**LOTS 4, 5 & 301 (5) WARTON STREET, COTTESLOE
PROPOSED EIGHT MULTIPLE DWELLINGS
SUBMISSION OF REVISED PLANS**

Planning Solutions acts on behalf of Cottesloe Investments WA Pty Ltd, the proponent of the proposed development at Lots 4, 5 and 301 (5) Warton Street (**subject site**).

**ATTACHMENT 1
REVISED DEVELOPMENT PLANS**

DRAWING TITLE
GROUND FLOOR OPEN SPACE
Figured dimensions take precedence over scale. Verify dimensions on site.

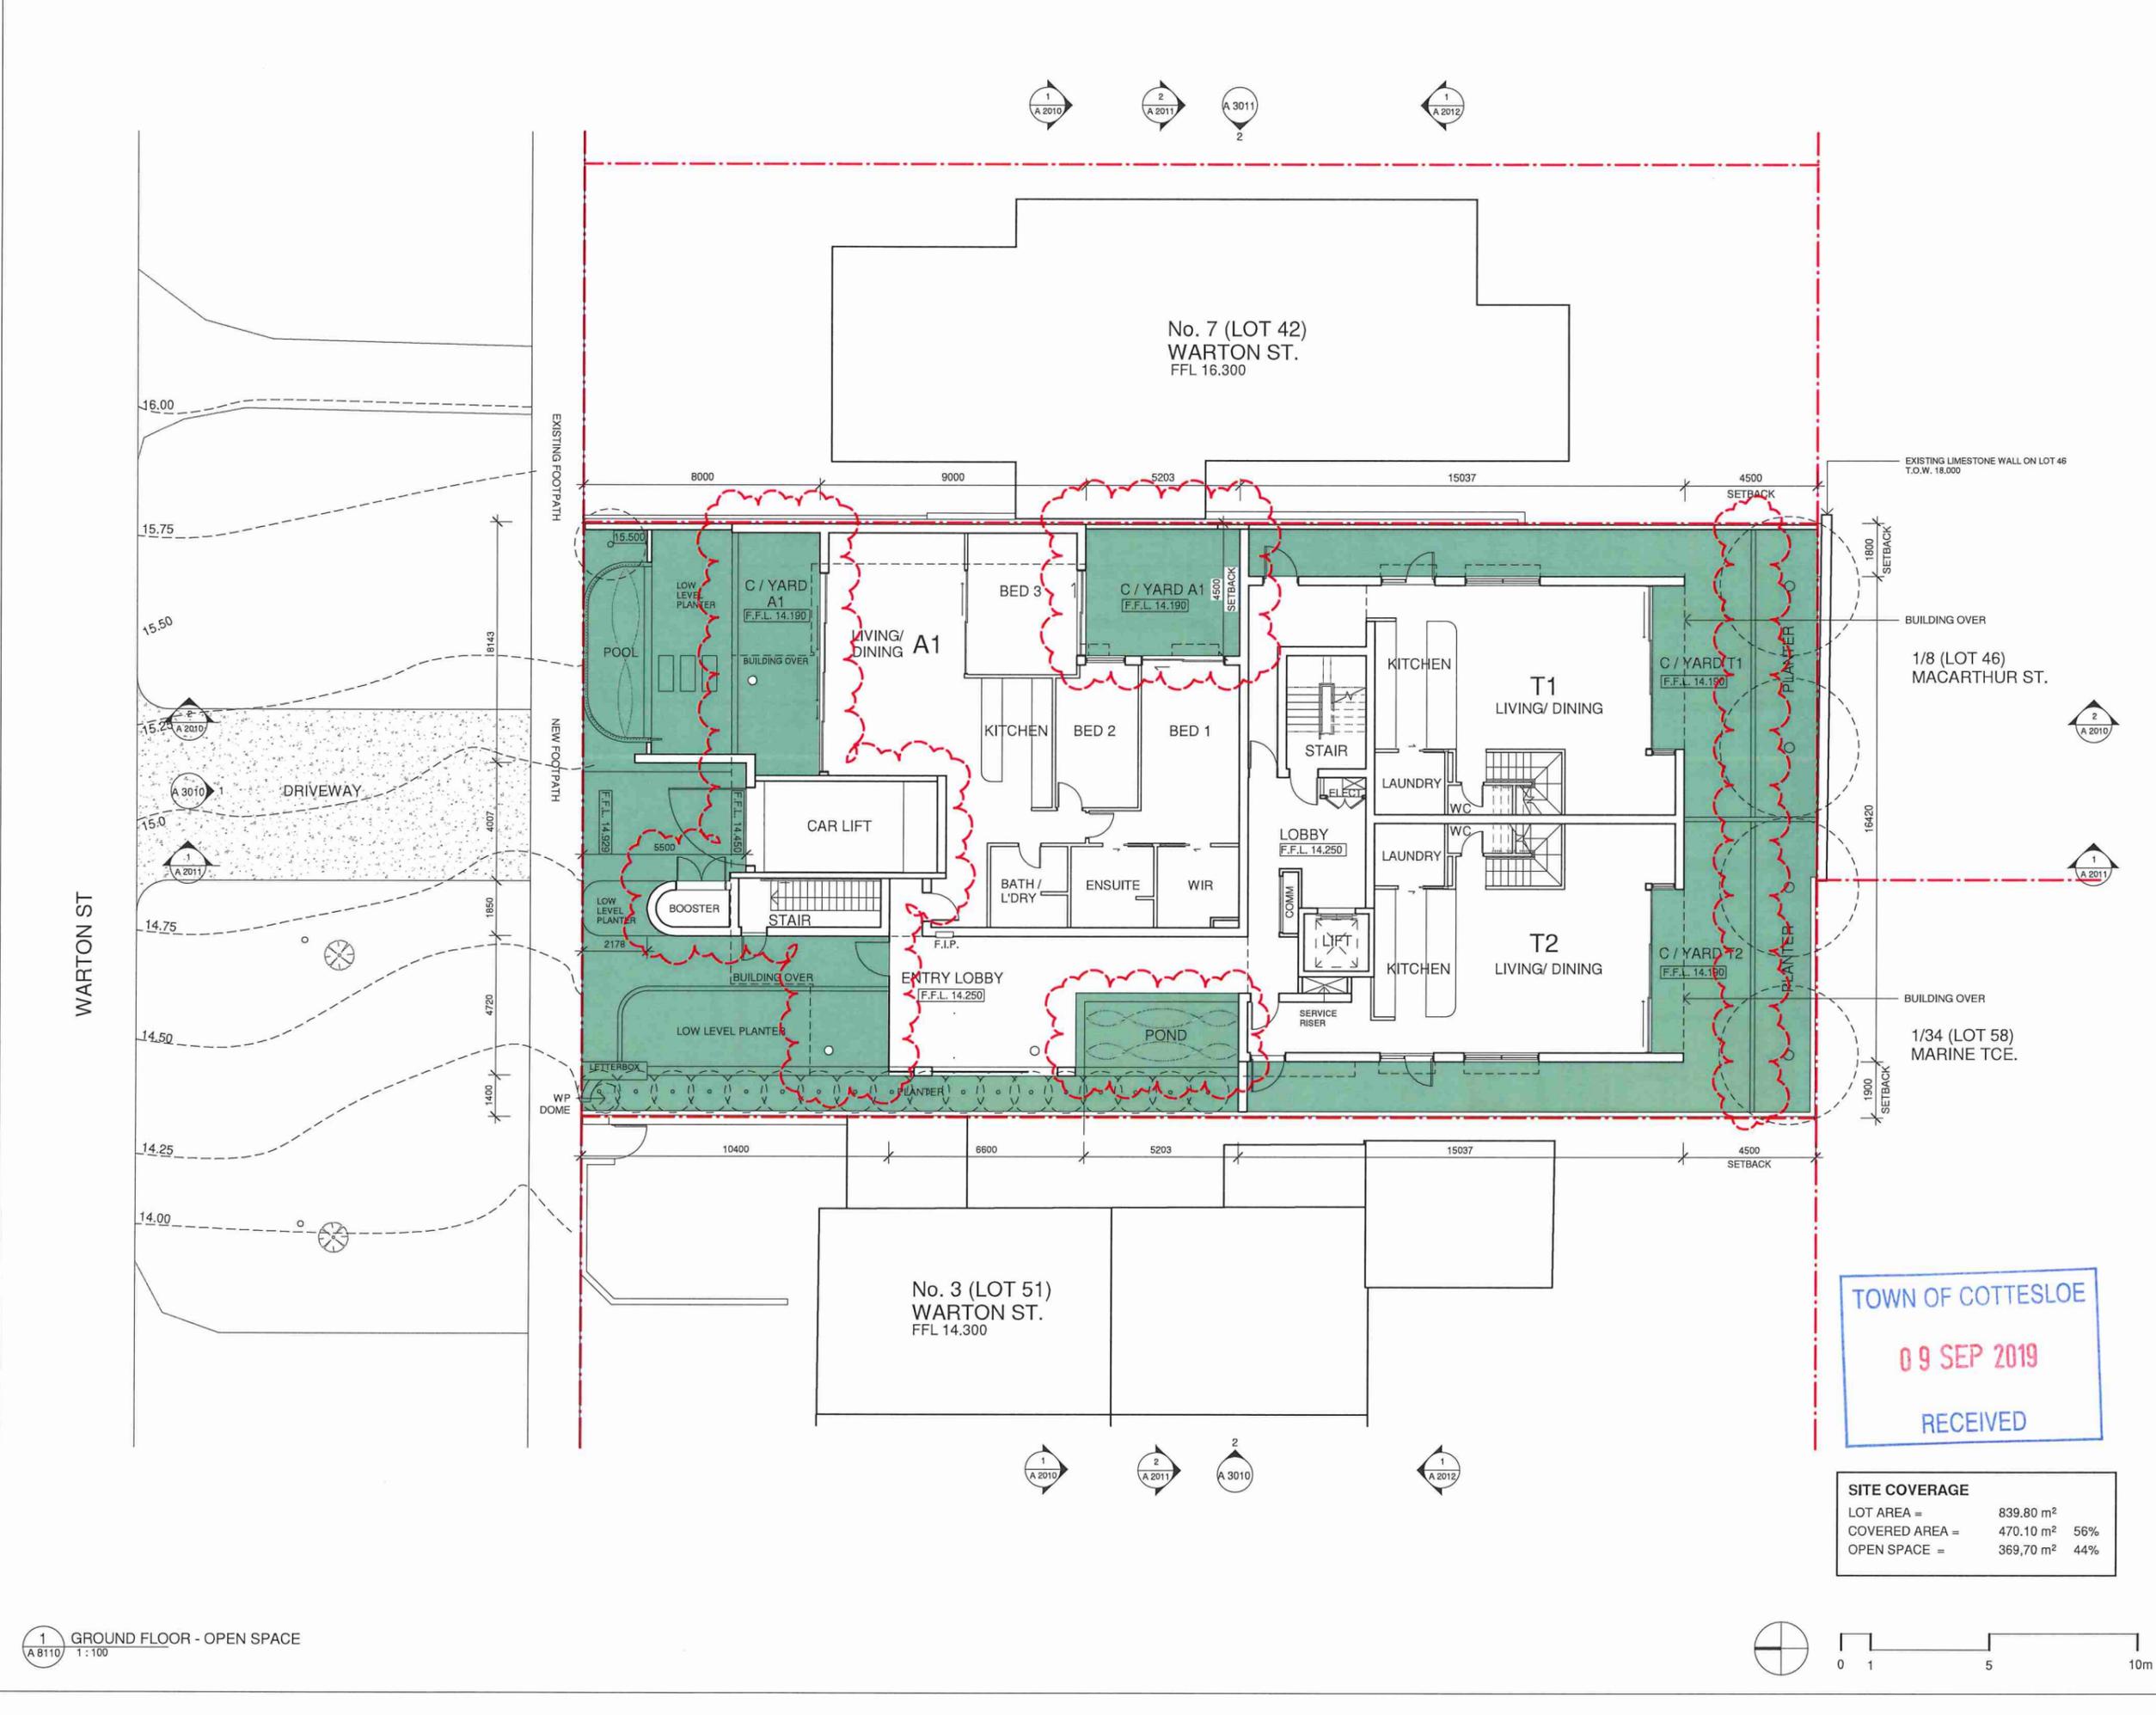
The revisions have **increased the open space from 41.3% to 44.0%**. This leaves the proposal just 9m² or 1% below the deemed-to-comply requirement of 45%.

For clarity, the rooftop terraces have not been included in the open space calculations. The calculated area is depicted in **Appendix 1**.

LOT AREA =	839.80 m ²	
COVERED AREA =	470.10 m ²	56%
OPEN SPACE =	369.70 m ²	44%

DRAWING TITLE
GROUND FLOOR GA PLAN

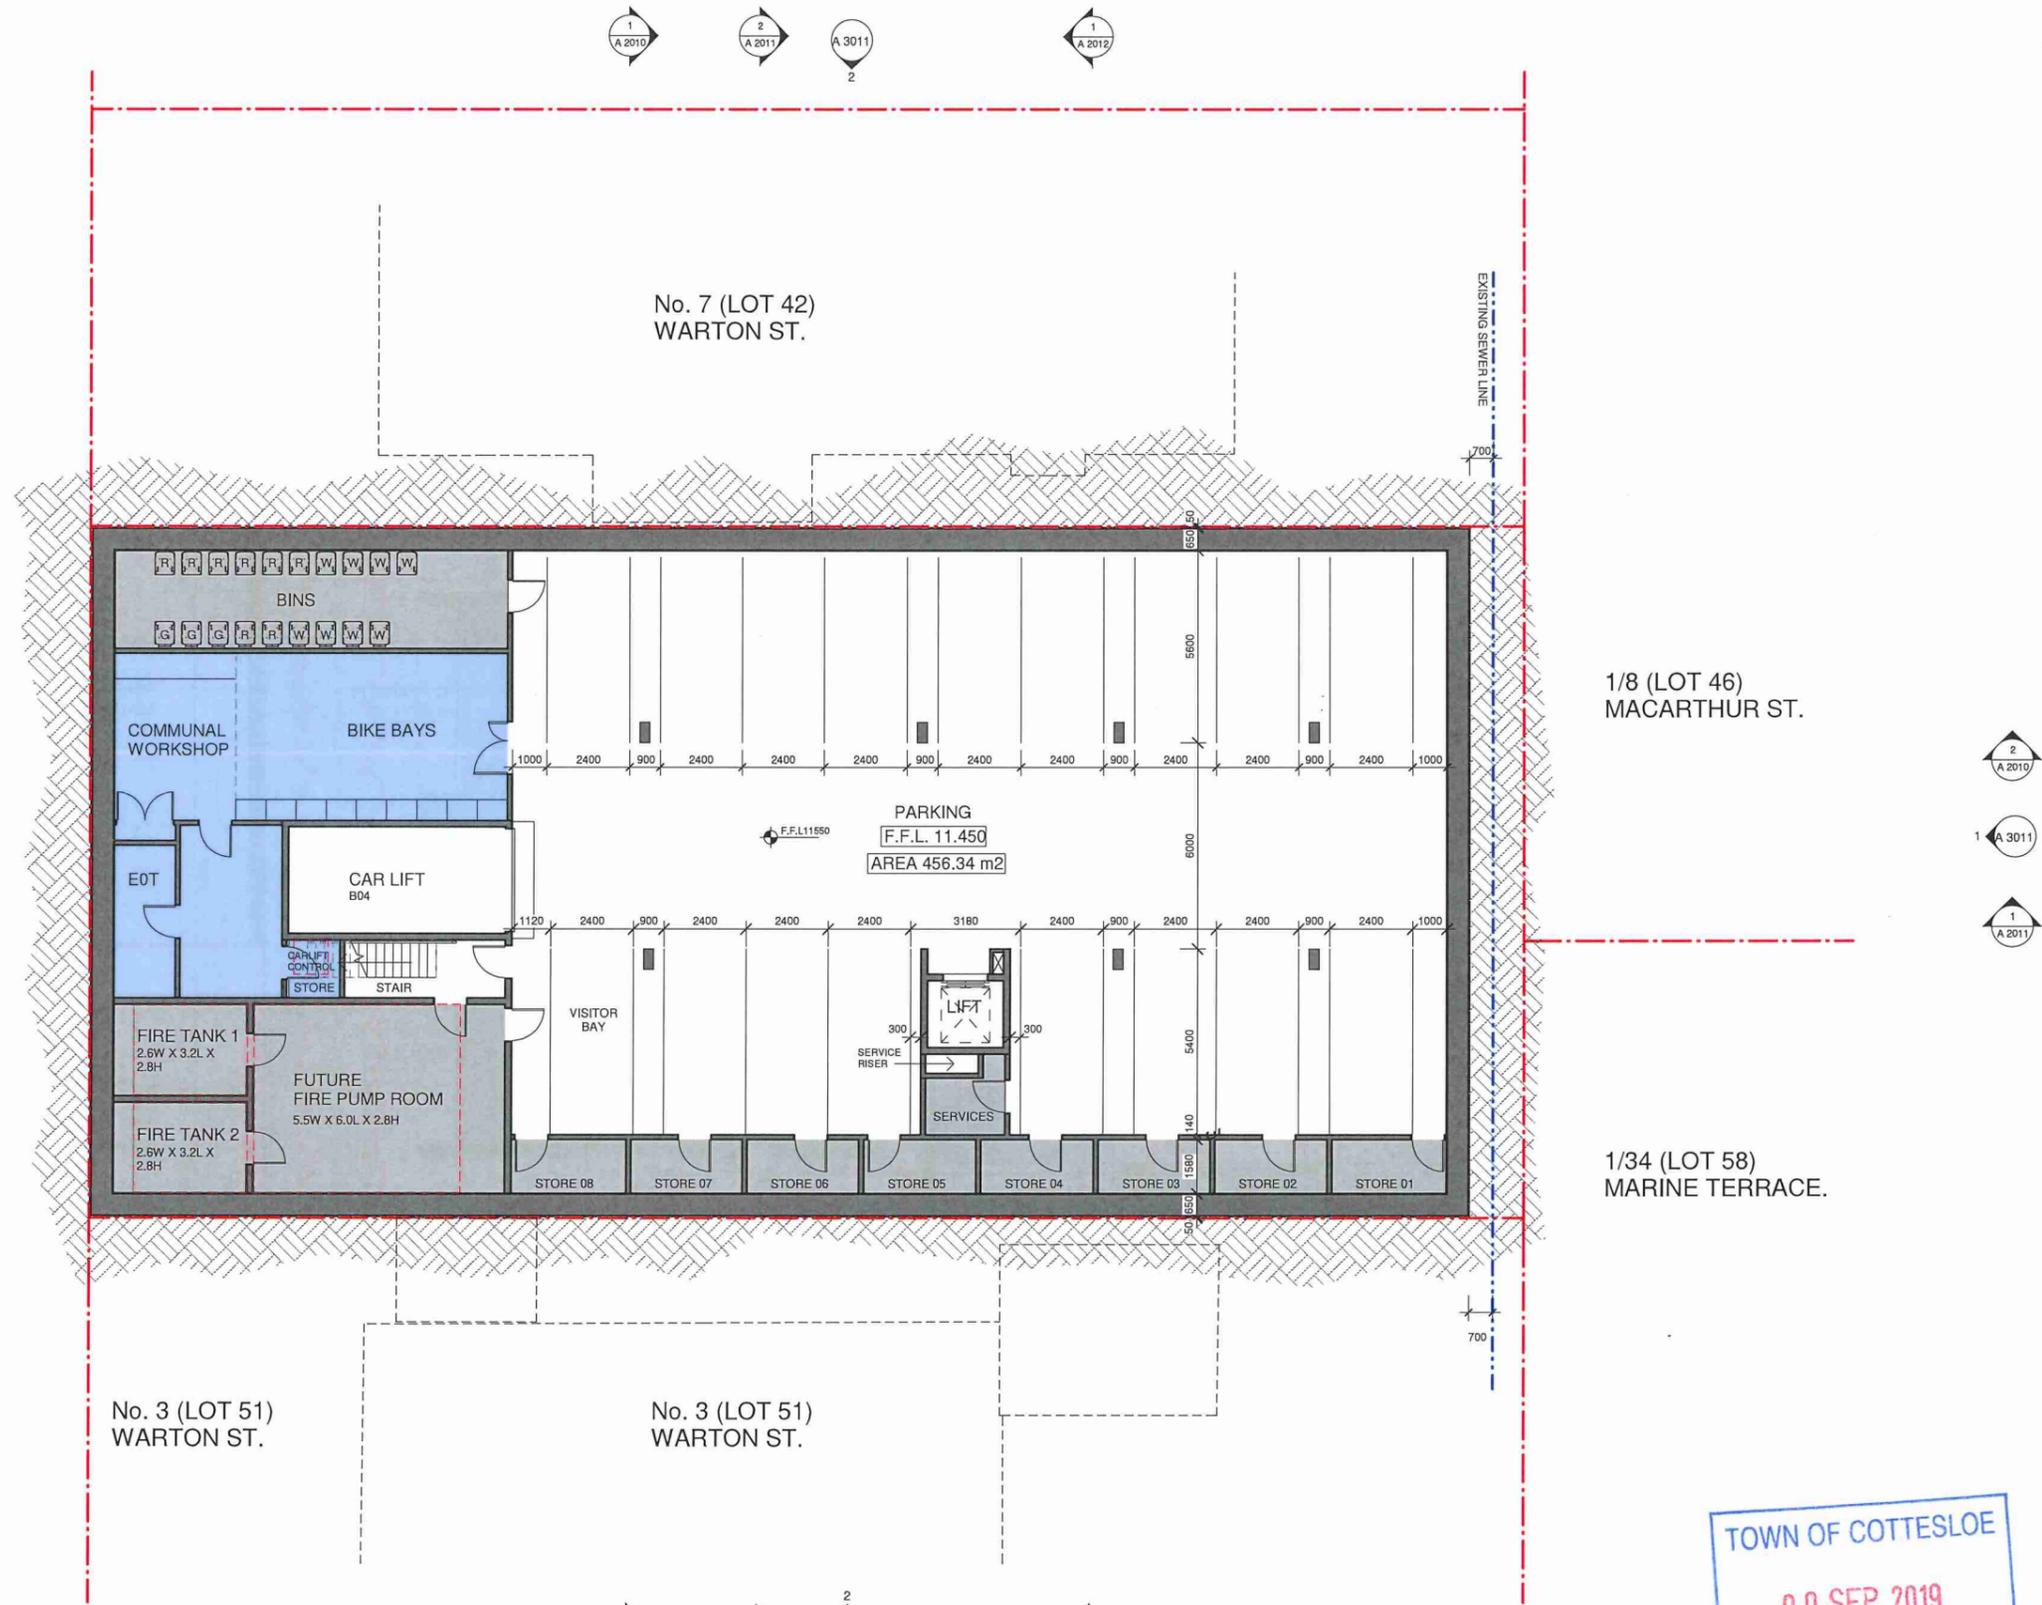
The primary amendment to the plans is to increase the street setback by an additional 1m. This increases the proposed setback from a 4m minimum / 5m average setback to a **5m minimum / 6m average setback**. This is consistent with what the proponent offered prior to the August Council Meeting.

3	The rear landscaping strip has been increased from 1.5m wide to 2m wide.	
4	The pond is now located outside the lobby rather than inside the lobby.

DRAWING TITLE
BASEMENT GA PLAN

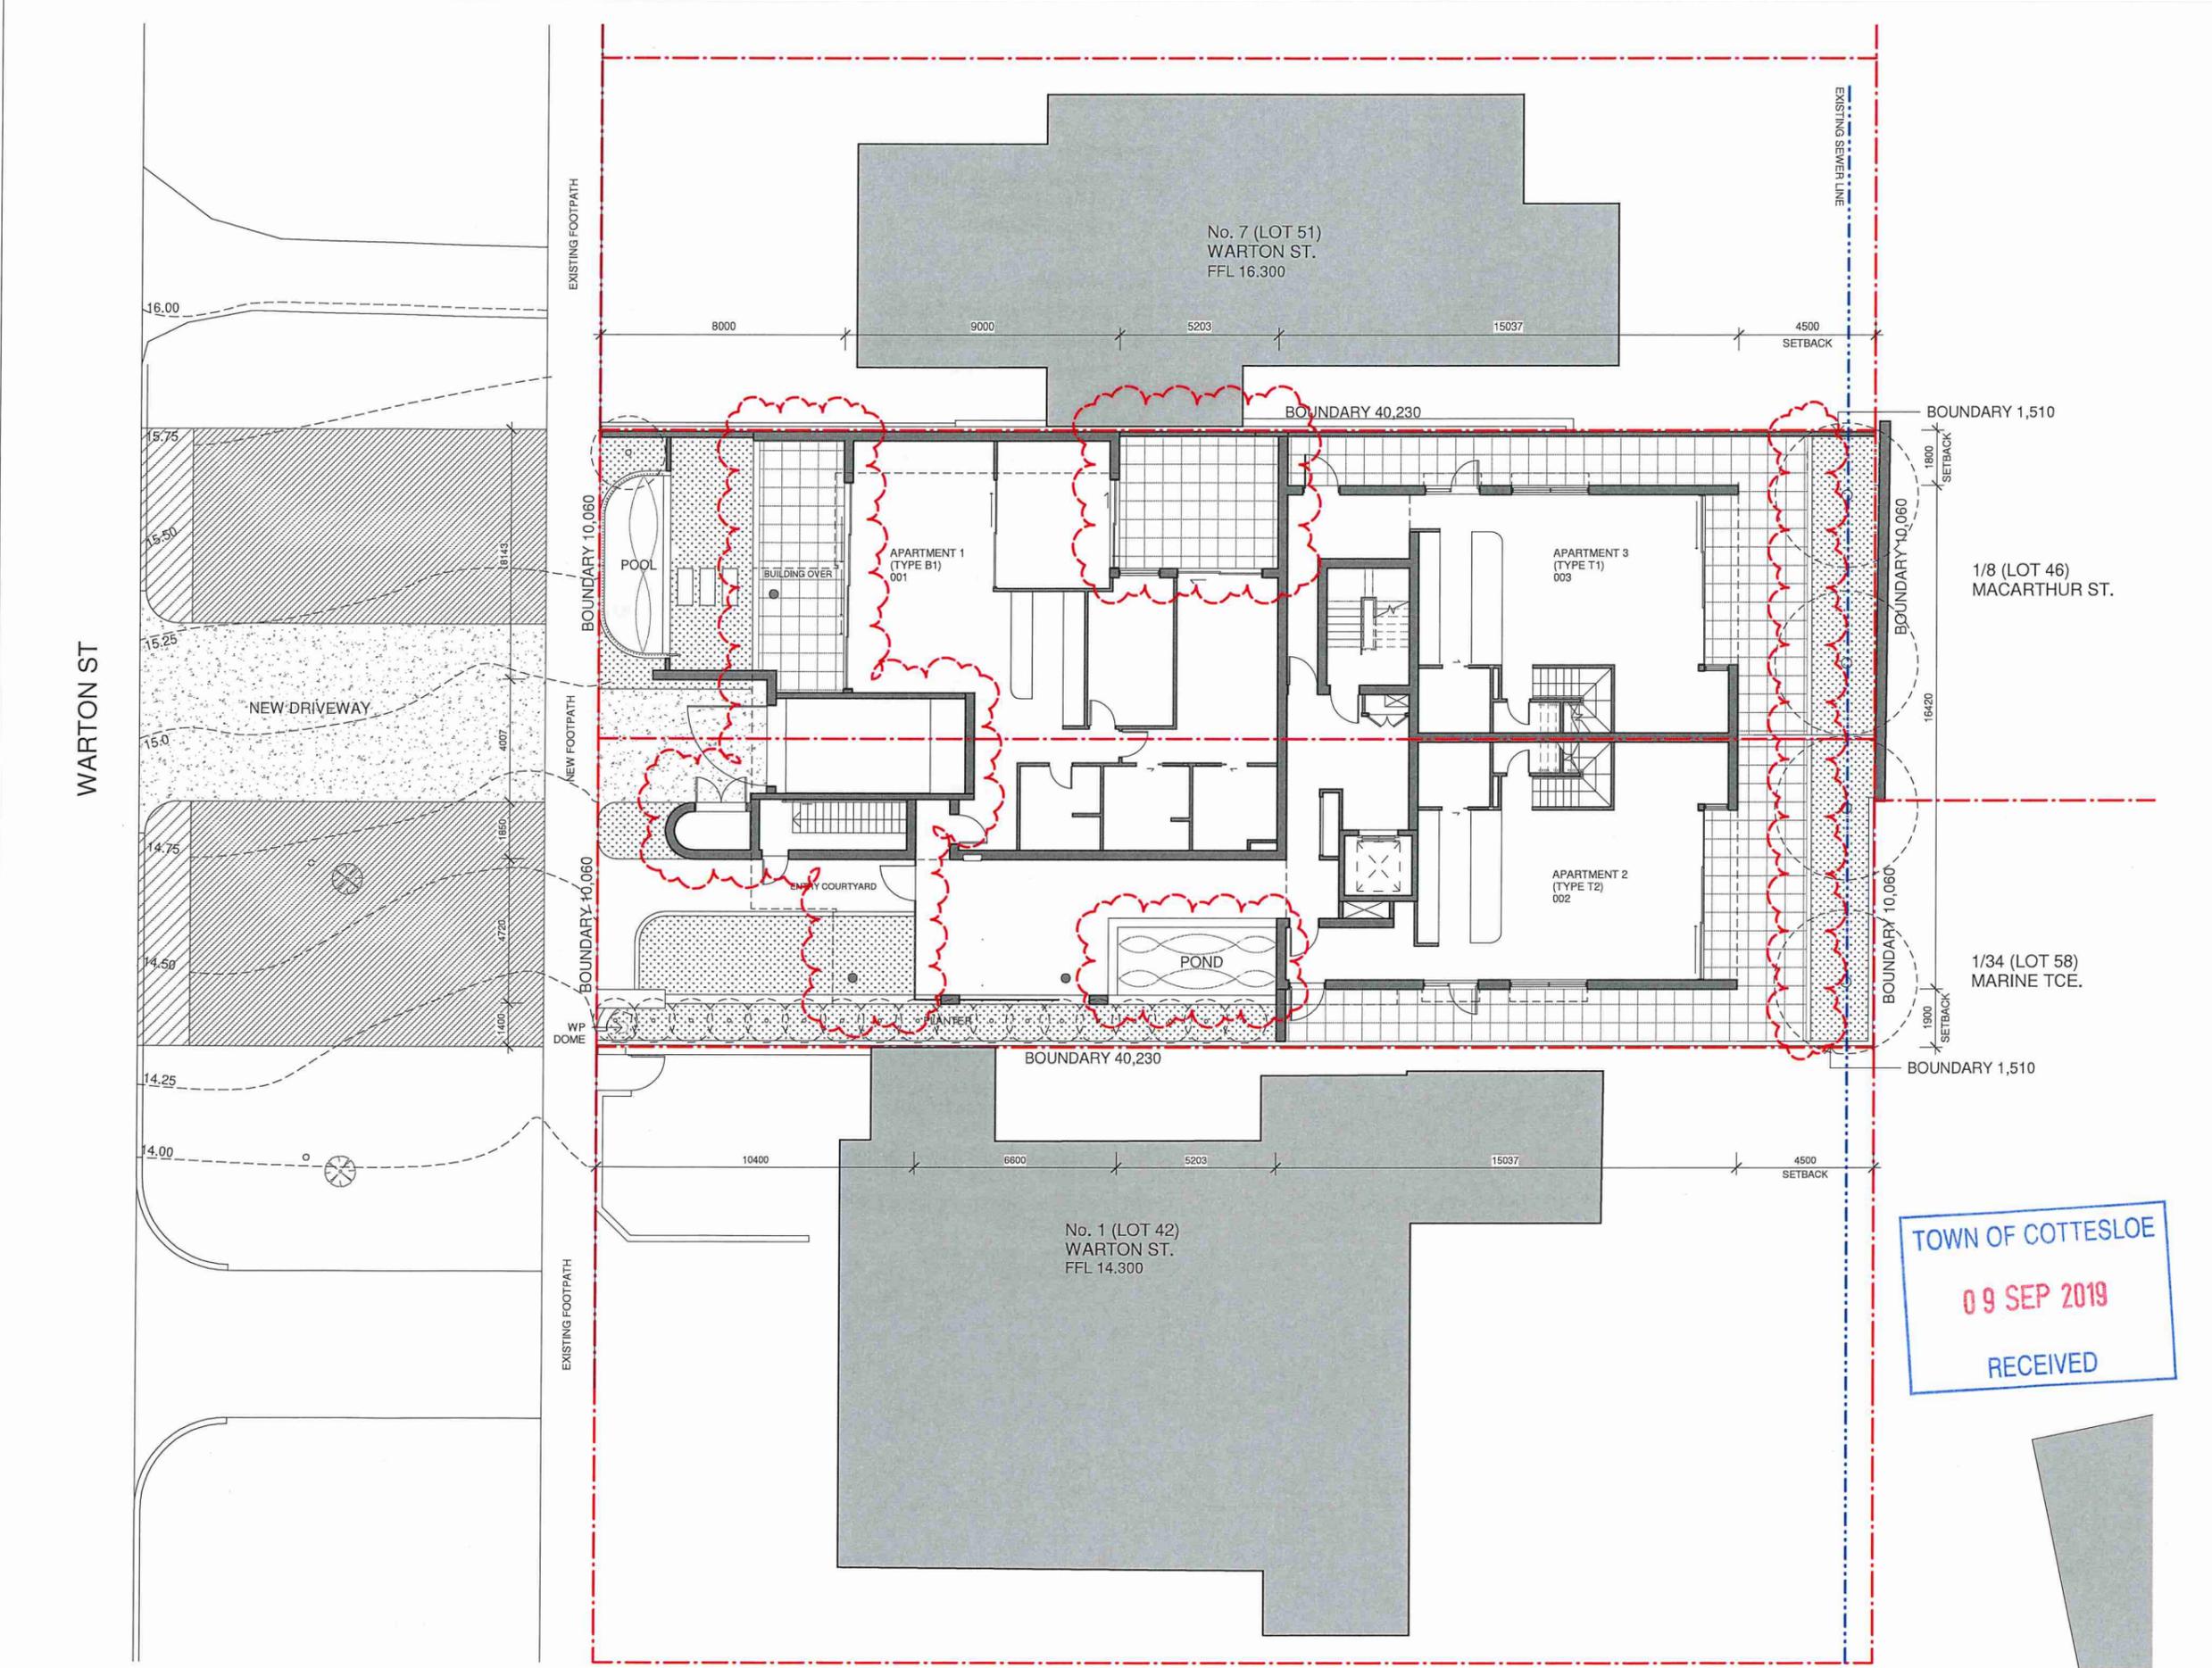
No.	Modifications	Comments / Notes
1	Revised basement car parking layout, reducing the number of bays from 19 to 17.	<ul style="list-style-type: none">The car lift has been moved further back which has necessitated a modified car parking layout in the basement.The proposed car park comprises one visitor bay and 16 residents' bays. The number of car bays remains compliant with the deemed-to-comply requirements of the R-Codes.
2	The rear courtyard of Apartment 1 reduces from 26.5m ² to 23m ² .	<ul style="list-style-type: none">This remains compliant with the minimum required area of 10m².
